PLANNING COMMISSION PUBLIC HEARING

DATE OF HEARING: July 28, 2010 DECISION DEADLINE: September 21, 2010 CMPT 2010-0004 Clearwire – Riverview at Leisure World PROJECT MANAGER: Judi Birkitt DIRECTOR: Julie Pastor, AICP ELECTION DISTRICT: Broad Run

EXECUTIVE SUMMARY

ROOFTOP KEYPLAN, SOUTH CORNER PLAN, PENTHOUSE ROOFTOP. & BALLAST SLED AREA PLAN

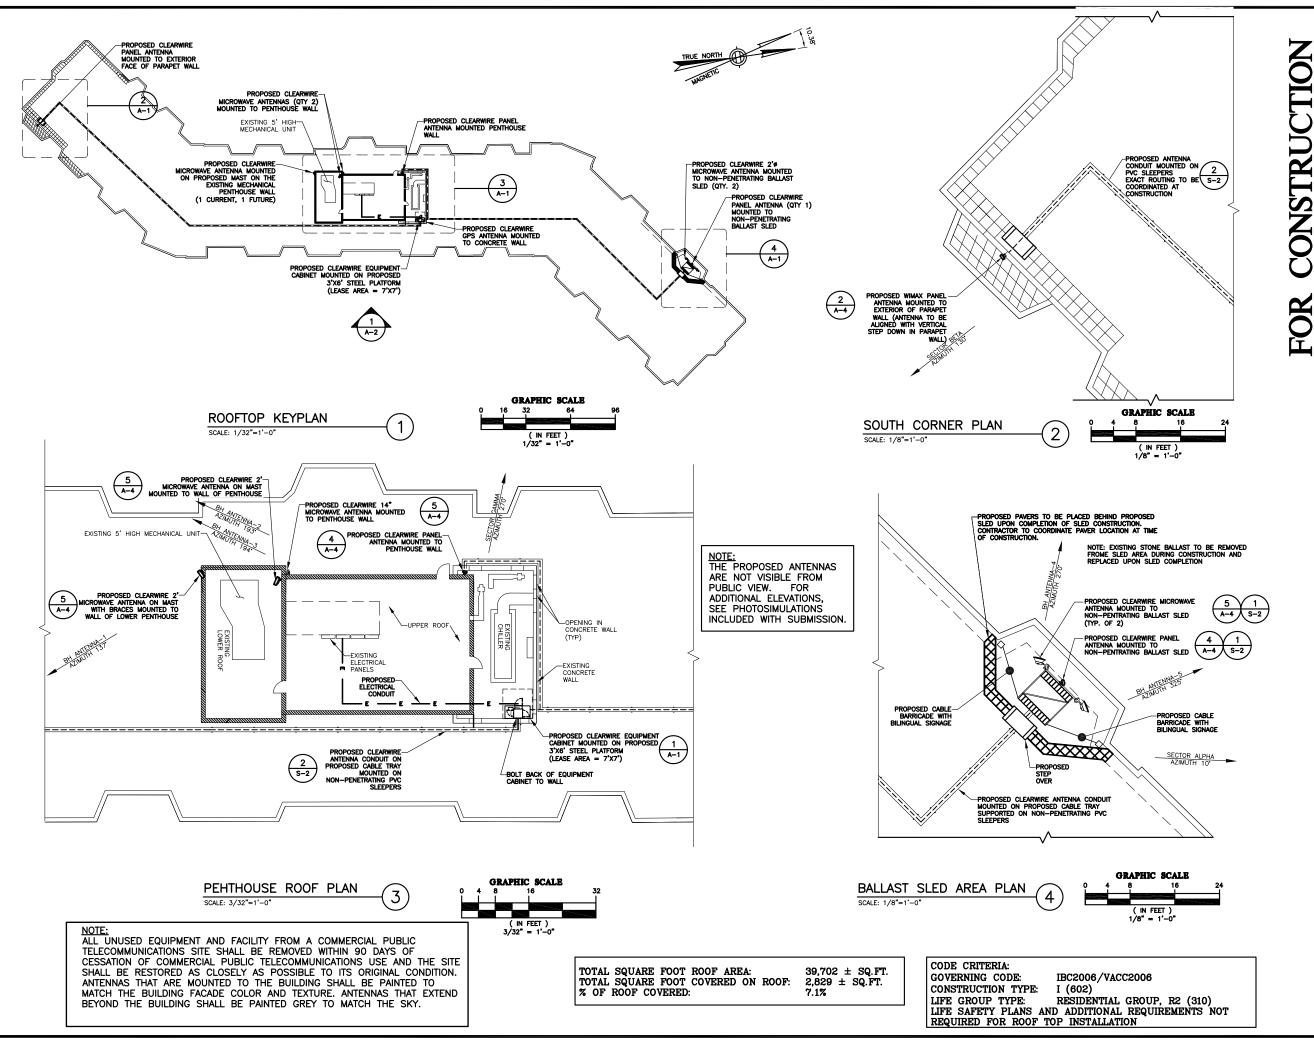
- 3. Sheet T-1, Scope of Work, states that 3 WIMAX panel, 5 Backhaul antenna, and 1 GPS antenna are being installed, which is a total of 9. Sheet A-1 details the location of 9 antenna. However, the SOJ states that 8 antennas are proposed. Revise the documents to be consistent in the total number of antenna proposed. Revise the SOJ to state the number of equipment shelters proposed. On sheet A-1, clarify which antenna are panel and which are microwave.

ELEVATION & ANTENNA SPECIFICATIONS

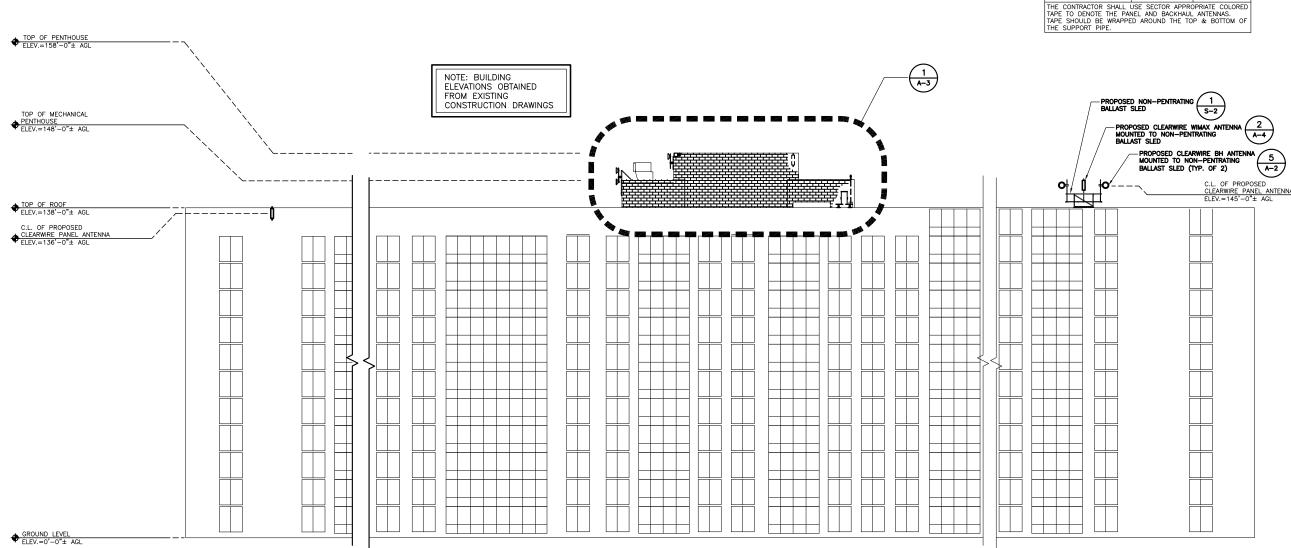
- 4. Section 5-618(A)(1) permits antenna in all zoning districts on existing structures 40' in height or greater. Sheet T-1 states the "Structure Height" as 158' while sheet A-2 states the height of the building as 118' and the height of the penthouse as 138'. Reconcile the height of the existing building.
